STAFF REPORT: 10-13-21 MEETING

APPLICATION NUMBER: 21-7521

ADDRESS: 19355 PARKSIDE

SCOPE: WINDOW REPLACEMENT

140 BOTTOM LEFT – one stationery/casement unit to be replaced with laundry vent
NEED CATALOG CUT TO CONFIRM DESIGN AND FINISH

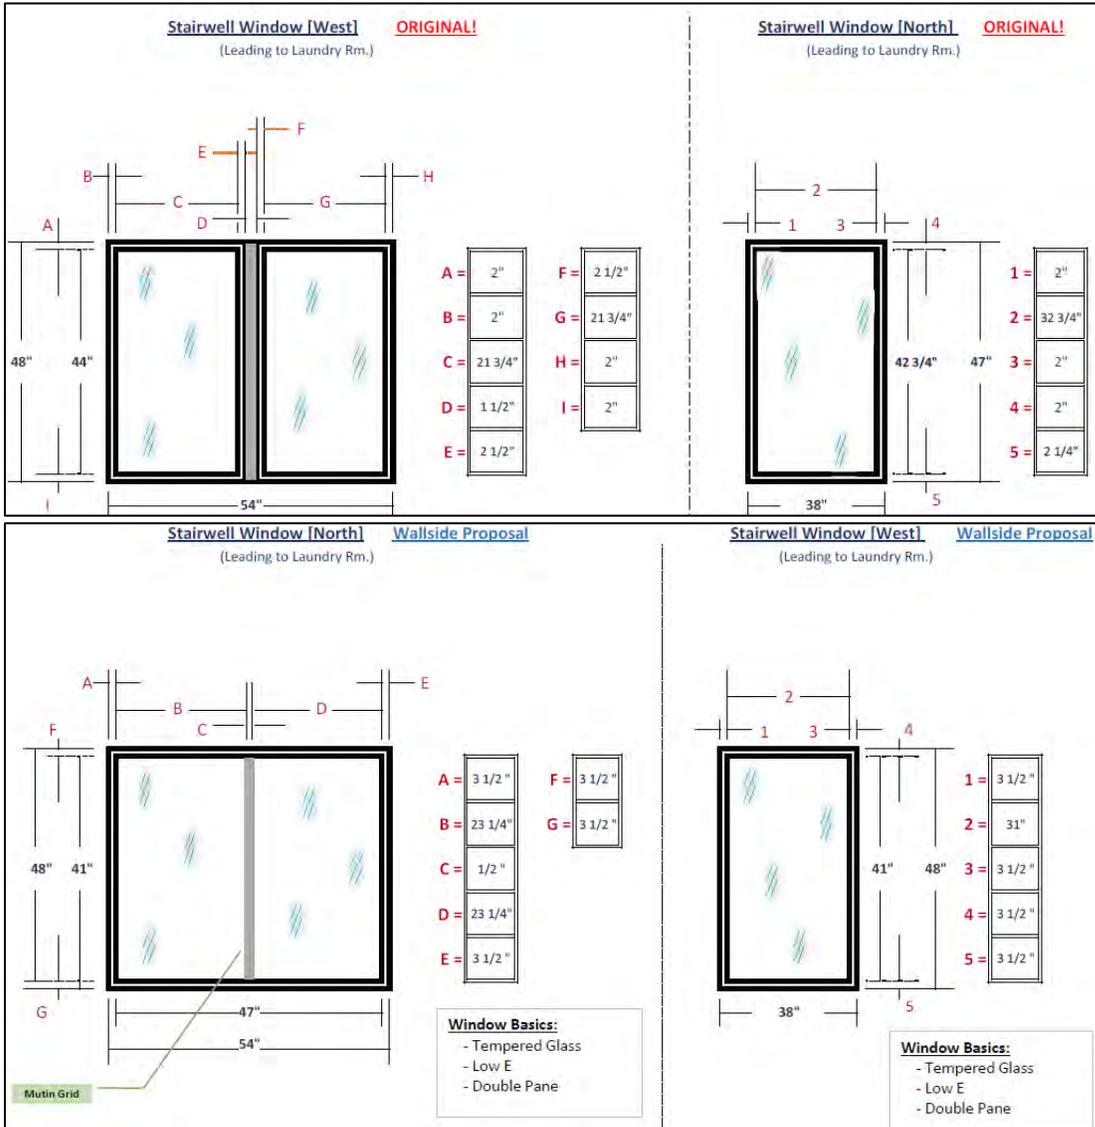
- Rear Elevation, Lower left opening: Dryer vent is proposed for the opening – staff requested catalog cut to confirm material, finish, and design of the vent.

BW 1 & 2 - Stairs

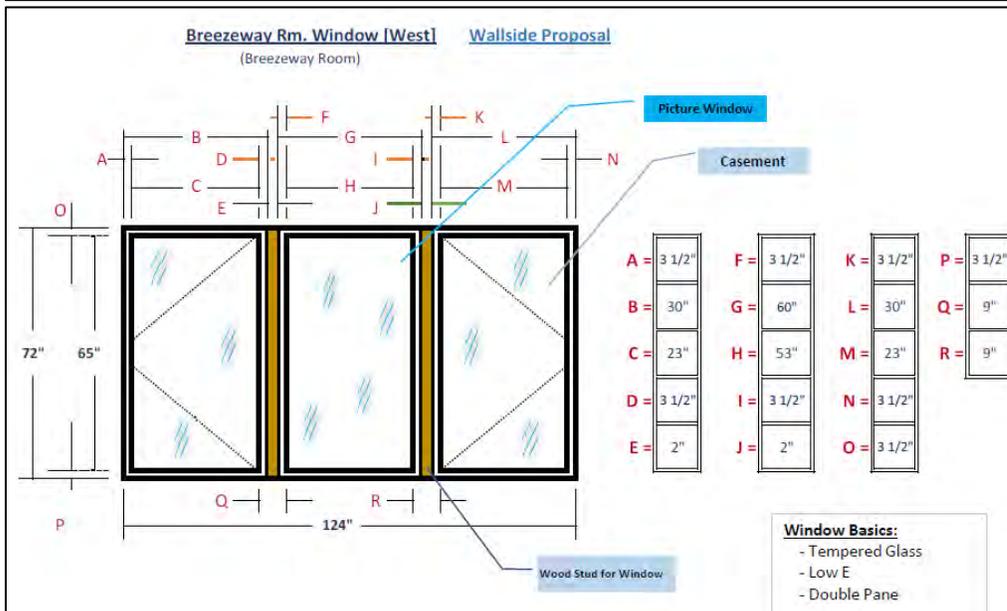
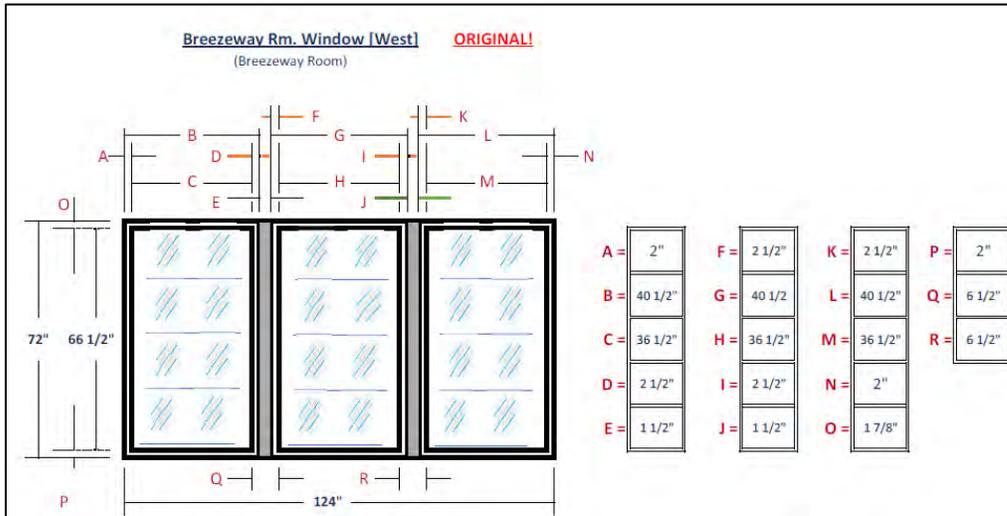
- Vinyl windows are proposed to replace the historic aluminum-framed jalousie windows. As noted below, the alteration to these openings will be dramatic due to the loss of the louvers, increased thickness of the window frames and the loss of the mullion for the north elevation stair window (with the mullion, a strong uniform vertical rhythm of the stair and sunroom windows is present).

<i>Stairwell</i>	<u>Existing</u>	<u>New</u>	<u>Difference</u>
Vertical Sash (Stile)	2"	3 ½"	75% increase
Horizontal Sash (Rail)	2"	3 ½"	75% increase
Mullion	1 ½"	½"	A 1/2" between-the-glass muntin will be placed in the single north elevation window, replacing the two mullied windows.

Existing	New	Difference
Vertical Sash (Stile)	2"	3 1/2"	75% increase
Horizontal Sash (Rail)	2"	3 1/2"	75% increase
Mullion	1 1/2"	1/2"	The 1 1/2" wide structural mullion will be replaced with a 1/2" wide between-the-glass muntin.

BW4 – North Triple opening (center picture)

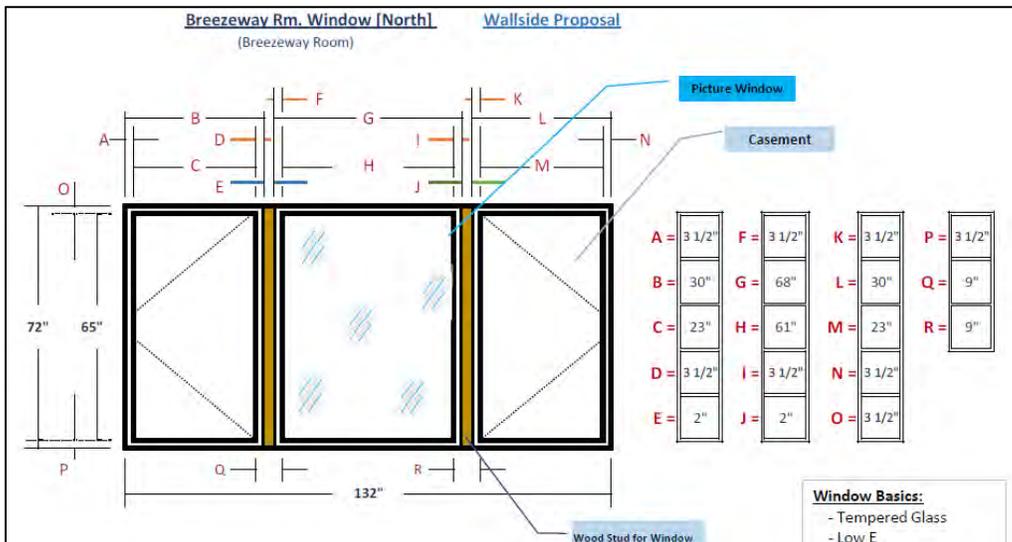
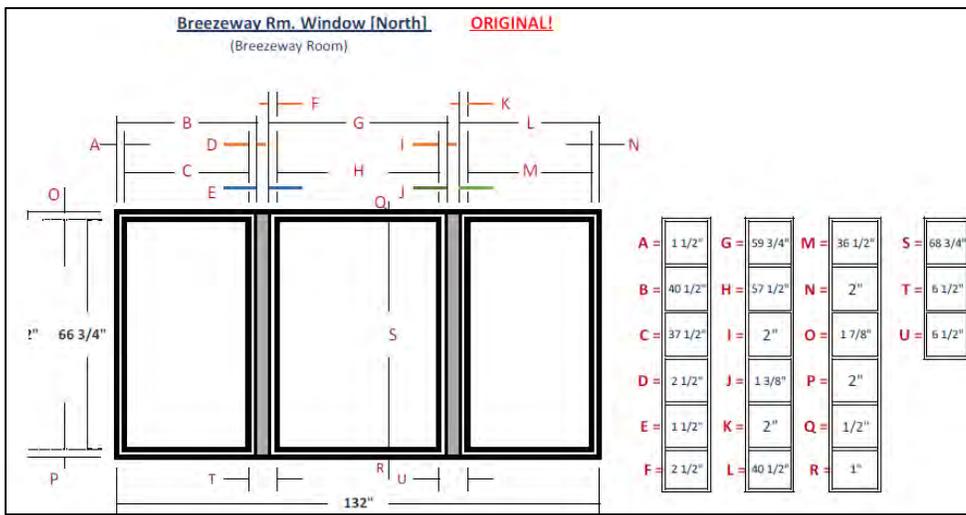
<i>Sunroom – North Elevation</i>	<u>Existing</u>	<u>New</u>	<u>Difference</u>
Exterior Vertical Sash (Stile)	1 ½"	3 ½"	133% Increase
Interior Vertical Sash (Stile)	2 ½"	3 ½"	40 % Increase
Top Horizontal Sash (Rail)	1 7/8"	3 ½"	75 % Increase
Bottom Horizontal Sash (Rail)	2"	3 ½"	75 % Increase

Existing	New	Difference
Exterior Vertical Sash (Stile)	1 1/2"	3 1/2"	133% Increase
Interior Vertical Sash (Stile)	2 1/2"	3 1/2"	40 % Increase
Top Horizontal Sash (Rail)	1 7/8"	3 1/2"	75 % Increase
Bottom Horizontal Sash (Rail)	2"	3 1/2"	75 % Increase
